Application No: 02DRB-00924 (SBP) Project #1001973  
Project Name: RICHFIELD PARK SUBDIVISION Fee: \$  
Agent: Advanced Engineering Phone No.# 899-5570  
Your request for (SDP for SUB), (SDP for BP), (PREL/FINAL PLATS), (MASTER DEVELOP. PLAN), was approved on 4/26/02 by the DRB with delegation of signature(s) to the following departments.

**7. Project #1001973  
Application # 02DRB-00924  
Richfield Park Subdivision- Helmick Homes**

**15. Project #1001973  
Application # 02DRB-00781  
Richfield Park Subdivision**

Re: Lot 42, Richfield Park, Containing 1.0714 Acre  
Zone Atlas Page C-17-Z, DRB # 1001973  
Site Plan For Building Permit

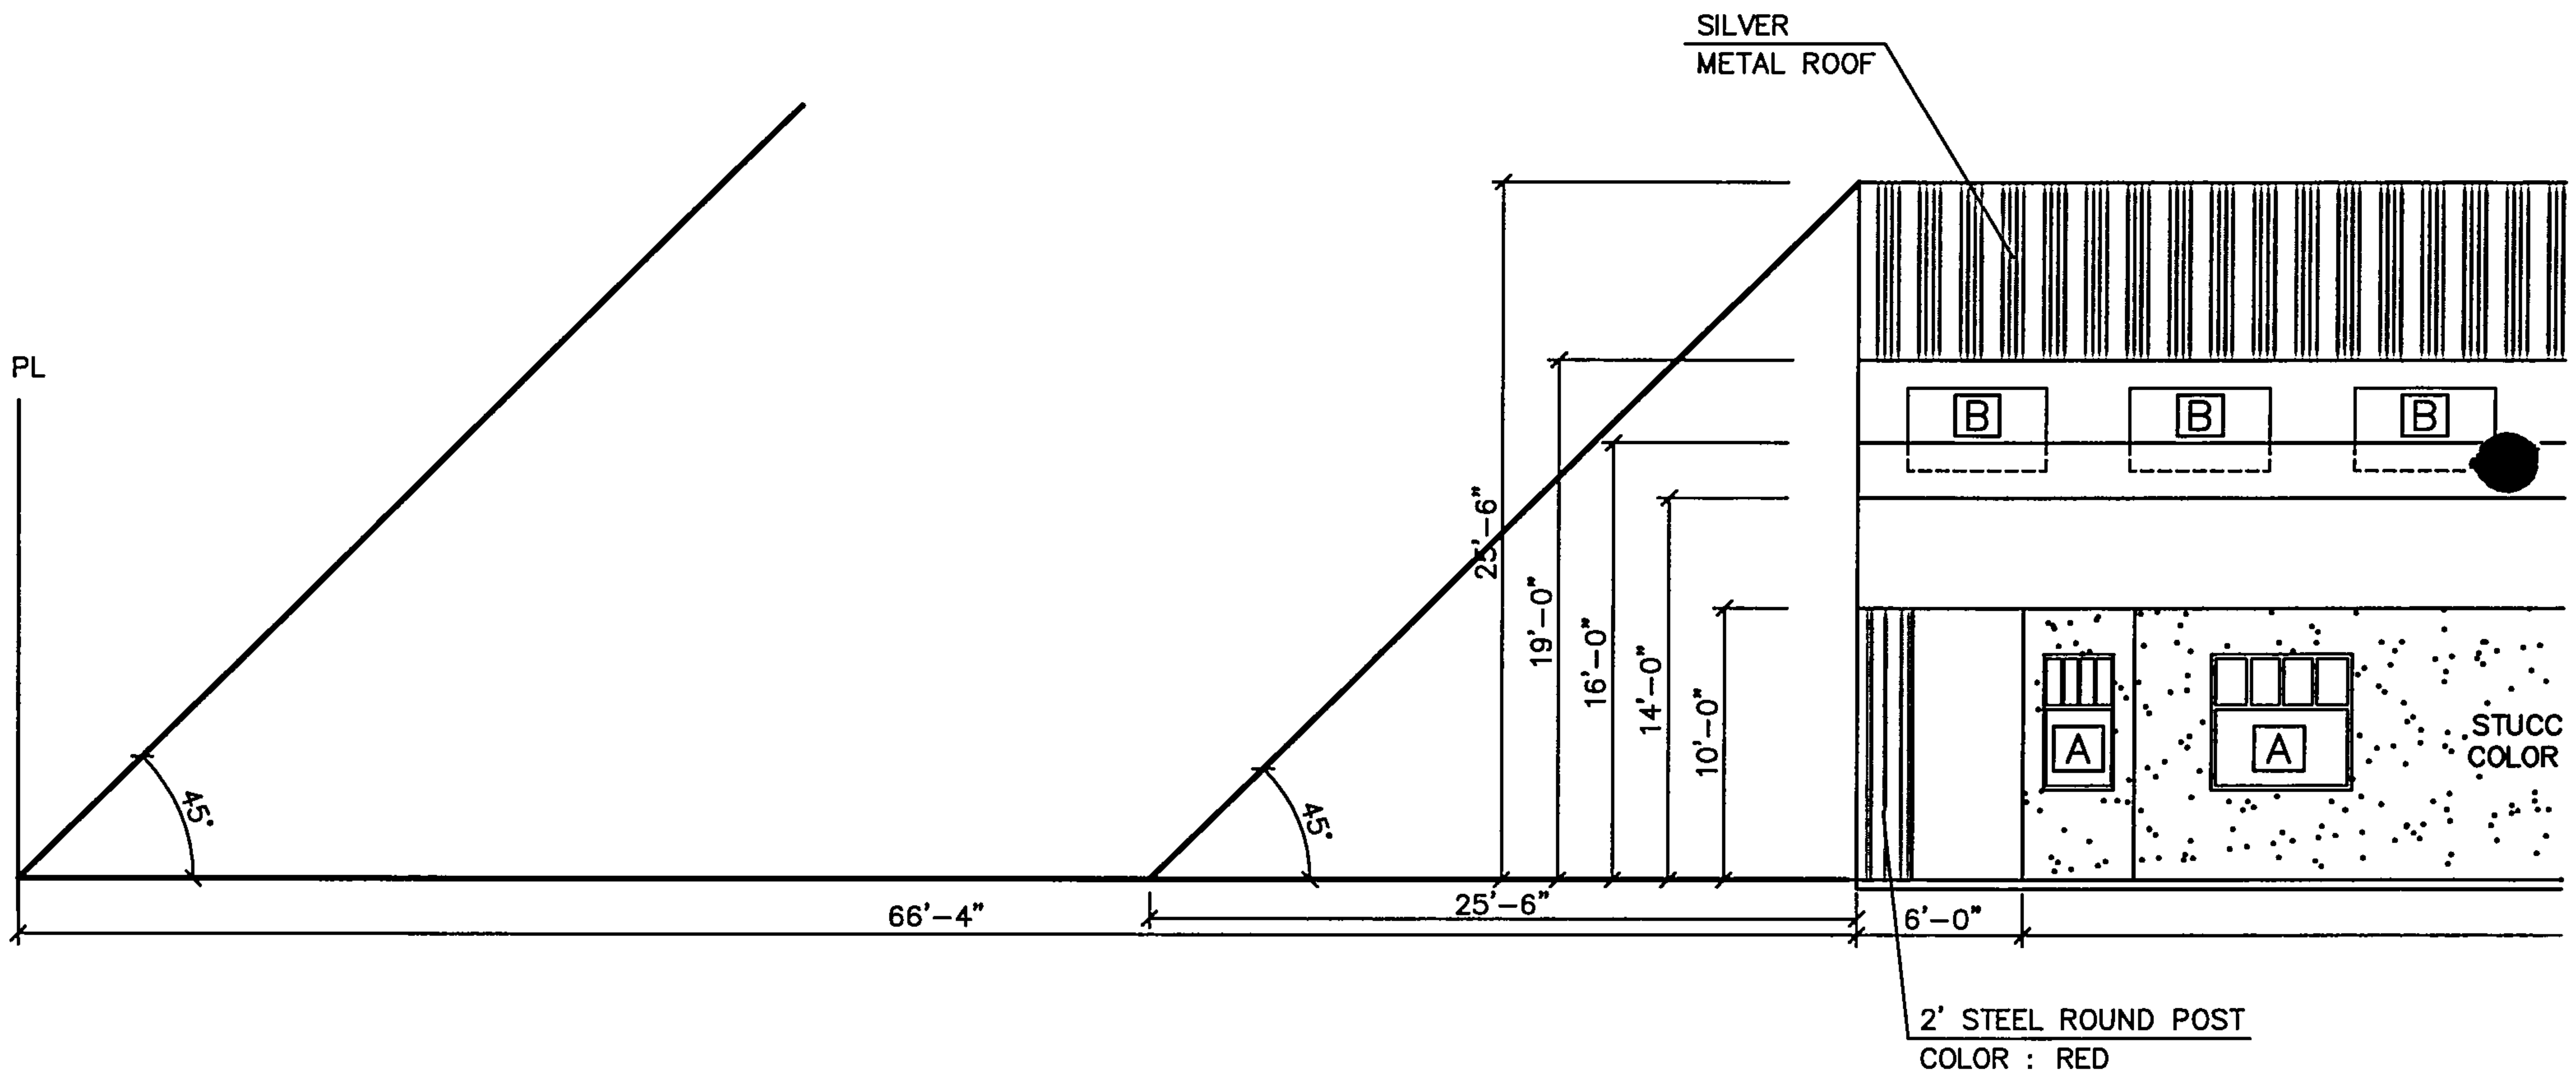
1. Re: the dumpster detail: Add the color of the CMU wall and the type of opaque gates proposed.
2. See Sheet 2 of 4 – Landscaping Plan.
  - a. Delete the language “Final landscaping layout and design to be determined upon receipt of final grading plan”.
  - b. The number of plants and type of plants indicated on the Plant Legend do not appear on the design. Also, why are half of the beds along Adams Street NE and Columbine Street landscaped only with gravel?
3. Please provide color samples of the stucco.
4. The spelling of “piched” under General Note #6, Sheet 1 of 4 needs to be corrected. The correct spelling is “pitched”.
5. A detail of the proposed parking lot and building mounted lighting needs to be added. Also, add a note that no fugitive light is allowed to escape the site.

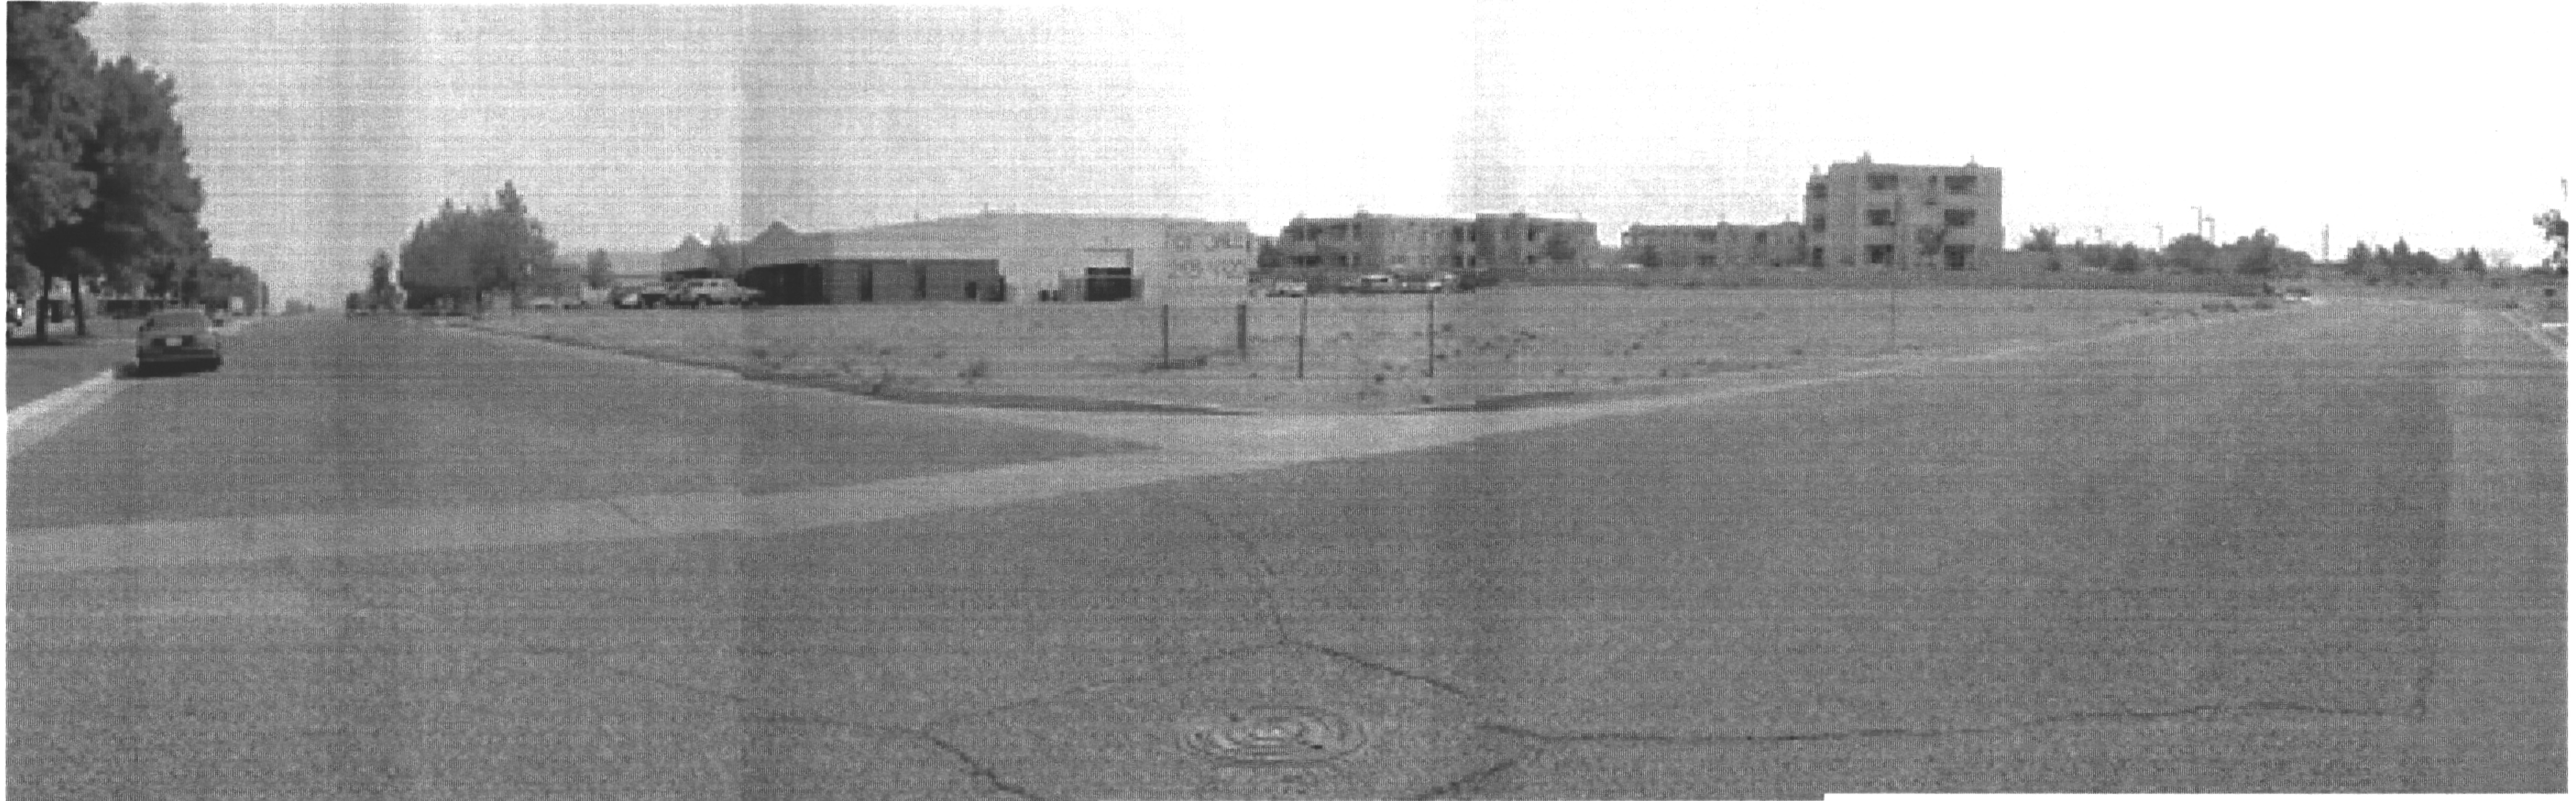
1. Future development must be in compliance with the Richfield Park master development plan and IP zoning. Please provide a copy of the master plan along with site plan submittal.
2. Please refer to the Site Data section re: the landscaping calculations. How was the figure 27,640 square feet derived?
3. Solid Waste must sign the site plan prior to DRB approval. Please contact Theresa Baca at 924-3631 or 761-8142.
4. Please provide details of the signage, lighting and facades. Call out colors, dimensions, and materials.
5. Refer to Section 14-16-2-19(C)(1) <sup>found</sup> regarding building height. Provide verification that the angle dimension is within compliance.
6. Please provide the landscaping plan along with the submittal. It should list the types and numbers of shrubs/trees as well as showing the proposed location of each plant.
